Re: **Work Plan Addendum for Additional Soil and Groundwater Investigation
Shell Service Station
31235 Mission Blvd.
Hayward, California**

**Re: Work Plan Addendum for Additional
Soil and Groundwater Investigation
Shell-branded Service Station
31235 Mission Boulevard
Hayward, California**

WORK PLAN ADDENDUM

FIGURE 1
PROPOSED MONITORING WELL LOCATIONS AND SITE AREA MAP

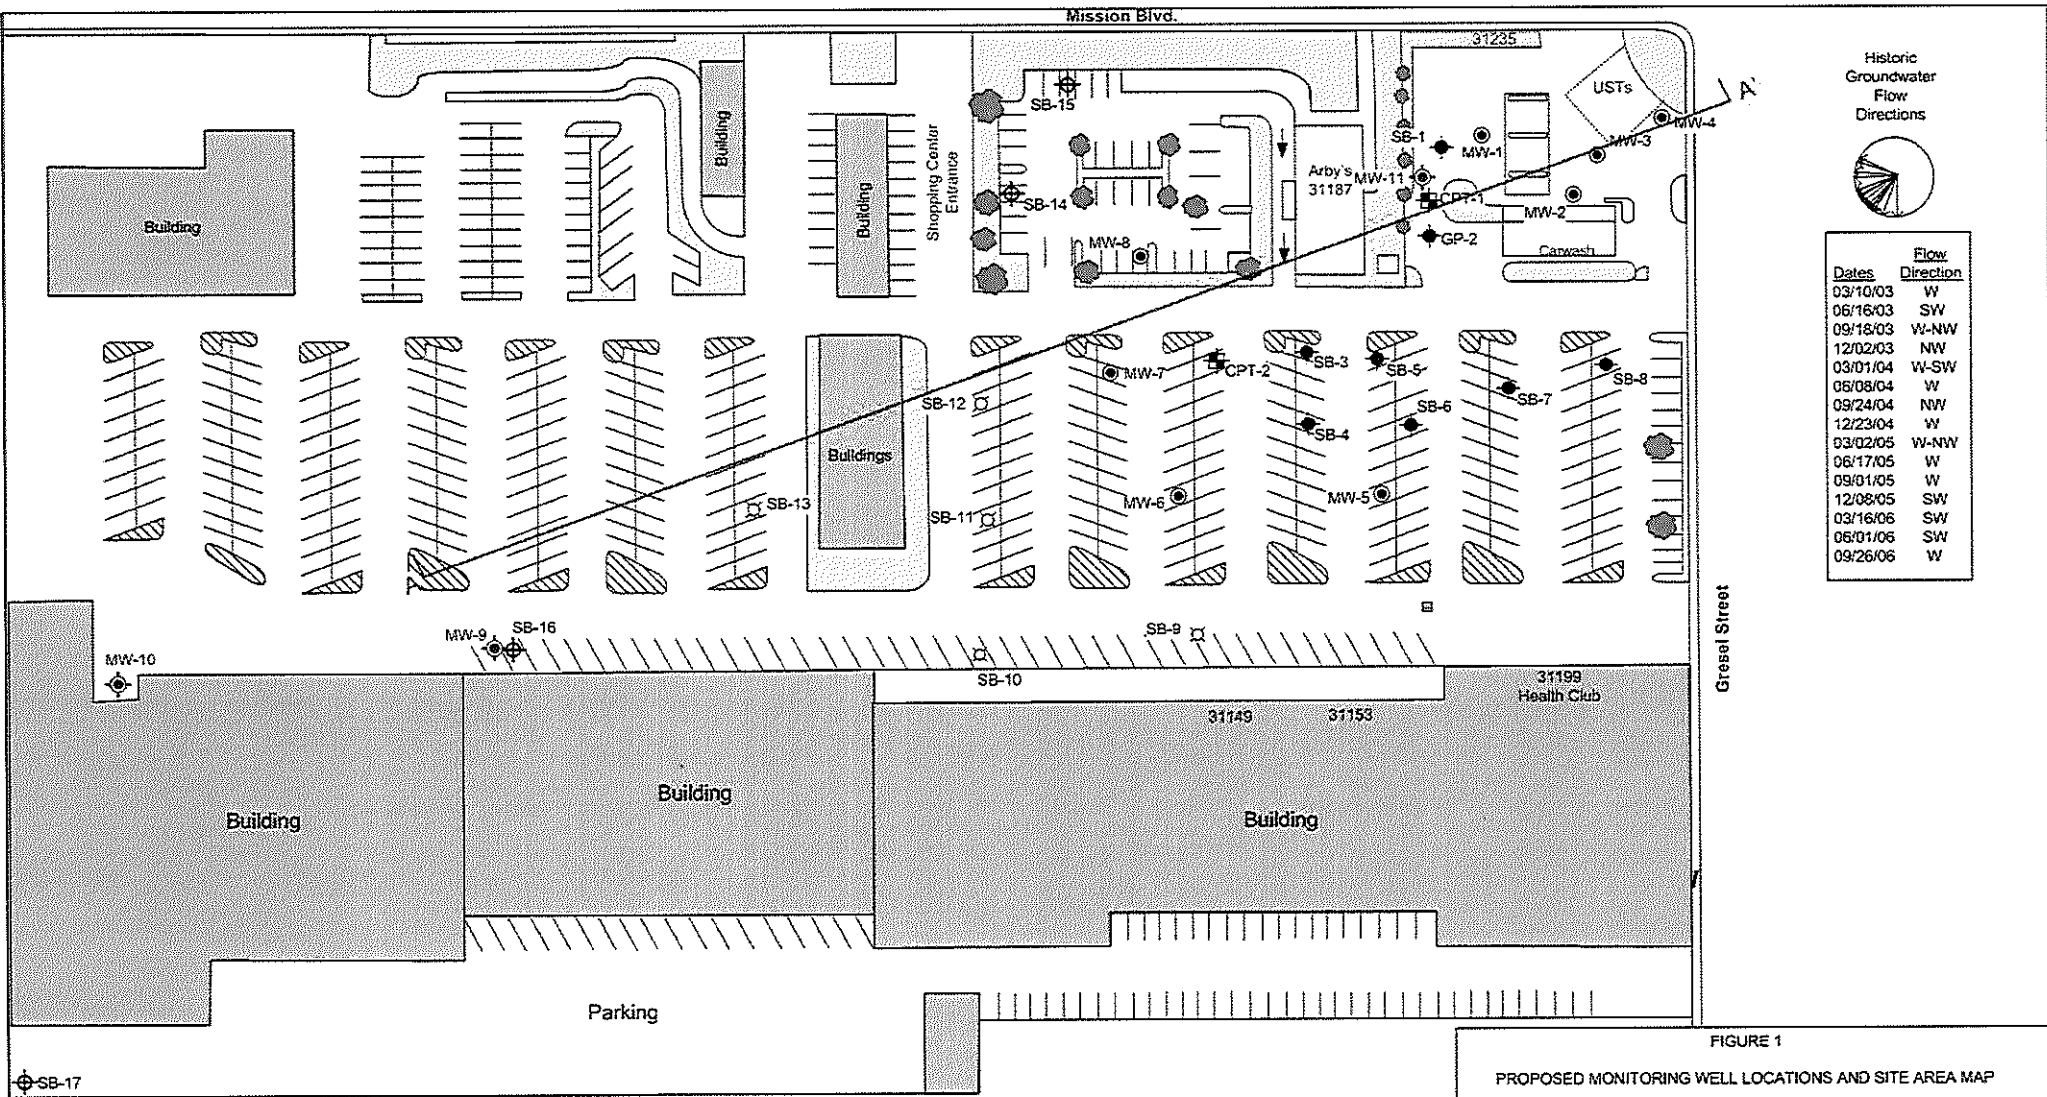
Delta proposes to install two additional groundwater monitoring wells, MW-9 and MW-10, at the locations shown on Figure 1. The purpose of these wells is to define and monitor the down gradient extent of the MTBE/TBA plume in the shallowest saturated zone. Delta also proposes the installation of one additional well, shown as MW-11 on Figure 1, to monitor the vertical extent of the MTBE/TBA plume.

Schematic Diagram of Proposed Conductor Casing for MW-11

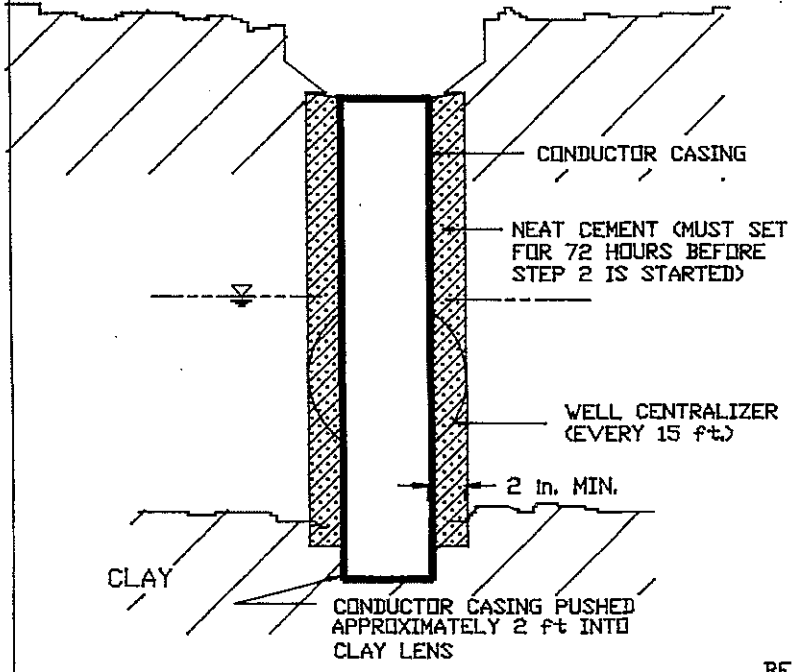
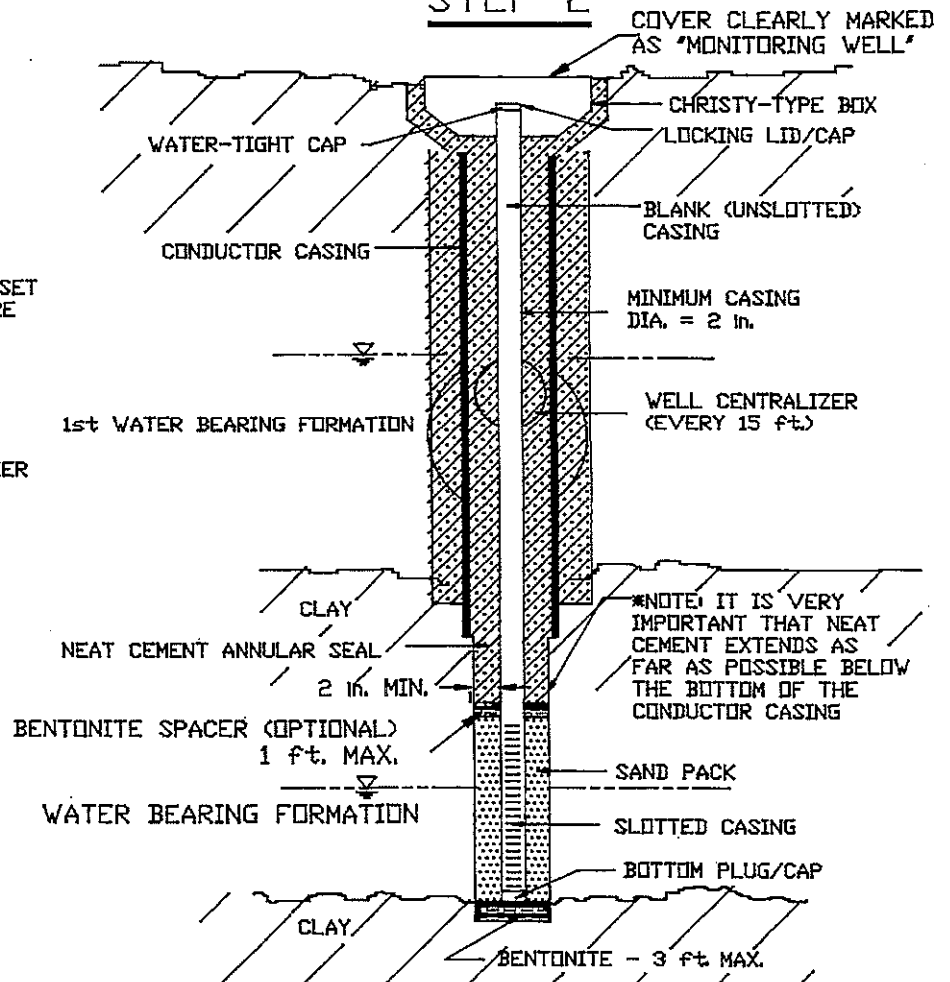
Please submit a revised work plan or addendum by **August 3, 2007**, describing the procedures for installing a conductor casing for the deep well, including a well construction diagram. Once ACWD approves the work plan and you have obtained drilling permits from the Alameda County Public Works Agency, it will be necessary to contact ACWD's Permit Section at (510) 668-4460 to schedule the proposed drilling dates for this work.

A 14-inch diameter boring will be drilled to a depth of approximately 34 feet at the location of MW-11 for the installation of a steel conductor casing. The boring log for CPT-1 shows a low-permeability layer of clayey silt and silty clay beginning at approximately 30 feet bg. The layer appears to be approximately five to six feet thick. The conductor casing will be used to

isolate the shallow water-bearing zone from the deeper water-bearing zones encountered at approximately 43 feet and 59 feet bg. The conductor casing will be installed with a minimum of 2-inches of annular space between the casing and the outer diameter of the borehole.

After the casing is set, it will be sealed in place by the injection of cement grout between the casing and the boring wall. After allowing the grout to set for 24 hours, the casing will be bailed or pumped dry to remove contaminated water accumulated from the shallow water-bearing zone. The casing will then be rinsed at least twice by filling the casing with clean water and then removing it. A sample of water from the final rinse will be collected and analyzed on a 24-hour basis prior to proceeding with the second phase of well installation. The sample will be analyzed for total petroleum hydrocarbons as gasoline (TPH-G), benzene, toluene, ethylbenzene and xylenes (BTEX), methyl tert-butyl alcohol (MTBE), and tert-butanol (TBA). The boring will proceed beyond the 34-foot depth only if all analytes in the rinse sample are below their respective environmental screening levels (ESLs). If not, another two rinse cycles will be performed and the rinse water re-tested.

After the conductor casing is installed and grouted, Delta will wait a minimum of 72-hours before advancing the boring for MW-11 to the total depth of 65 feet. The boring will be advanced using a 10-inch diameter hollow-stem auger. The monitoring well will be constructed with 4-inch diameter PVC casing and screened from approximately 55 to 65 feet bg using 0.010-inch slotted well screen.
